The Leicestershire County Council (A606 North and East Melton Mowbray Distributor Road) Compulsory Purchase Order 2020 (“CPO”)

The Leicestershire County Council (A606 North and East Melton Mowbray Distributor Road) Side Roads Order 2020 (“SRO”)

Your client: Jelson Limited (“Jelson”)

GENERAL ARRANGEMENT AND CPO OUTLINE SHEET 6 OF 21, drawing number [REDACTED]

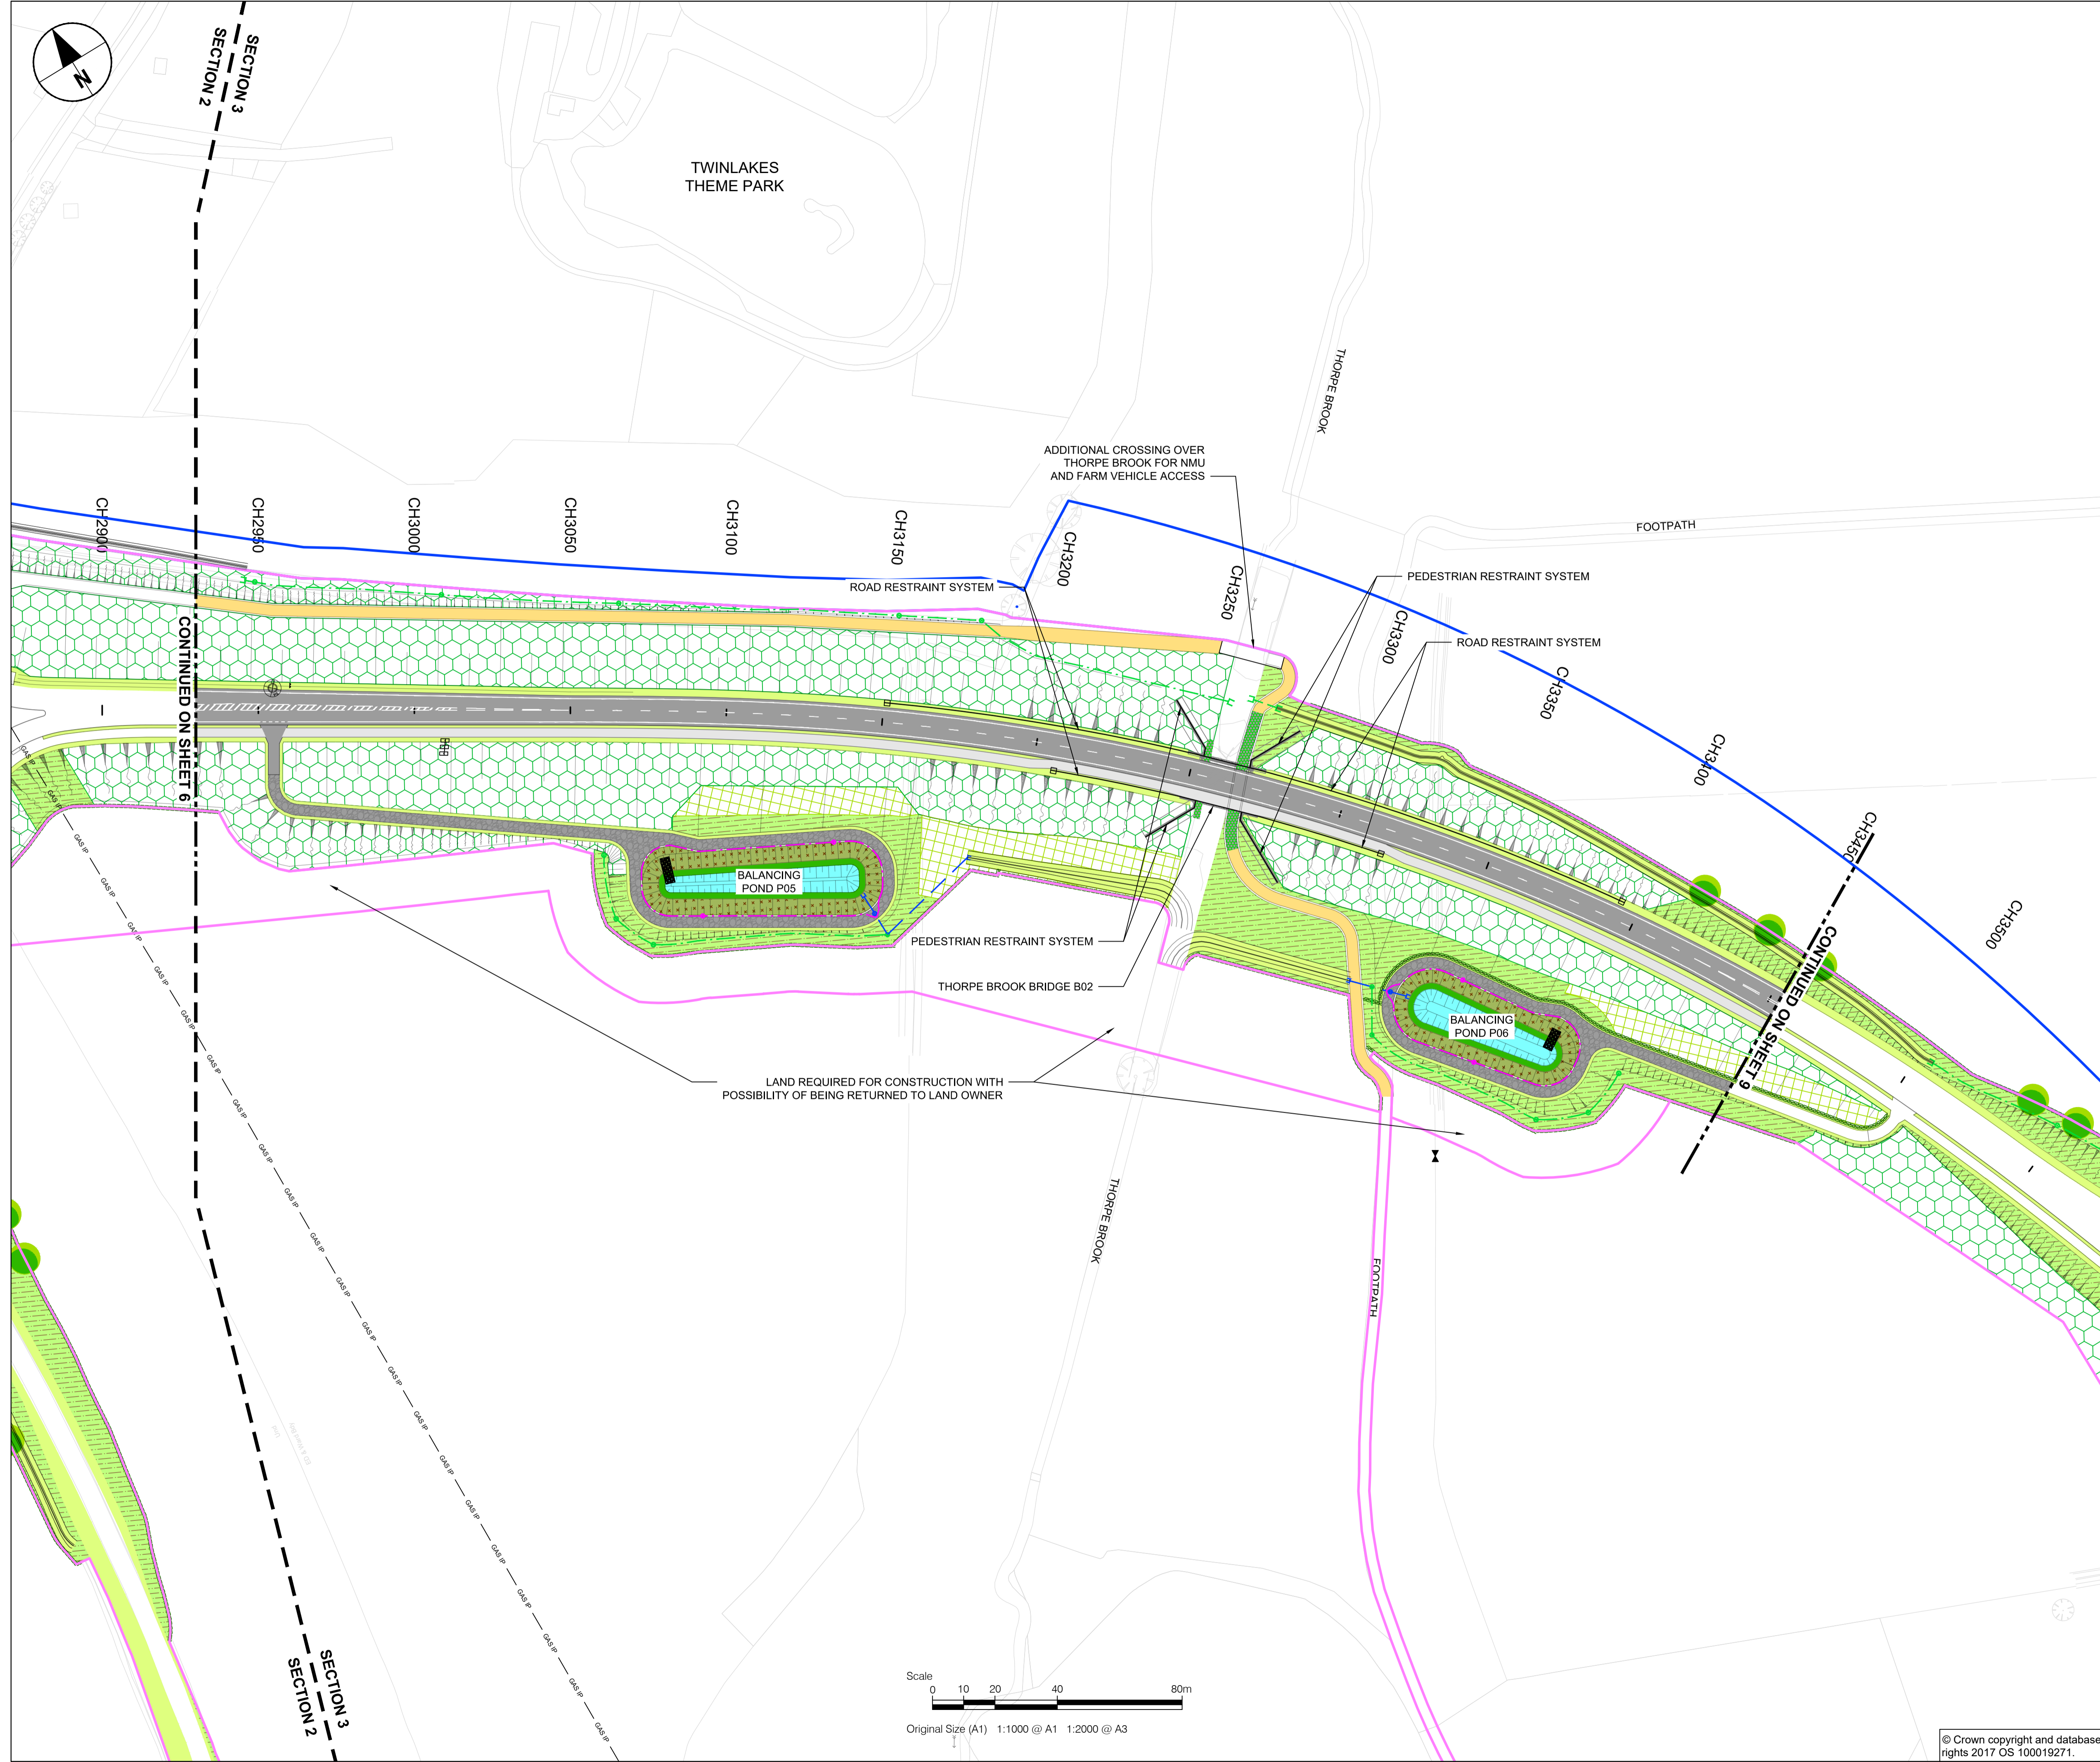
- 1.4. The Council remain committed to securing Jelson's interests in the land by agreement and are open to negotiation.
2. Your second objection is that the proposed land take is excessive; in Plots ■ and ■ appearing sufficient to deliver a dual carriageway road on a very shallow embankment.

- 2.4. Also attached to this response in ■■■■■ are plans which show the scheme General Arrangement overlaid with the CPO boundaries. It can be observed that the permanent construction is confined to Plot ■. The need for Plot ■ is a long-term operational requirement, being necessary for the construction of the road. As set out in the ■■■■■, this plot may be capable of being offered back to the owners on completion of the works, although the nature of the land may be altered.

- 2.5. Accordingly, the land take is the minimum required to deliver the Scheme.
3. Your third objection relates to the impact on retained land at Plots ■ and ■ and access to that land during and after construction.
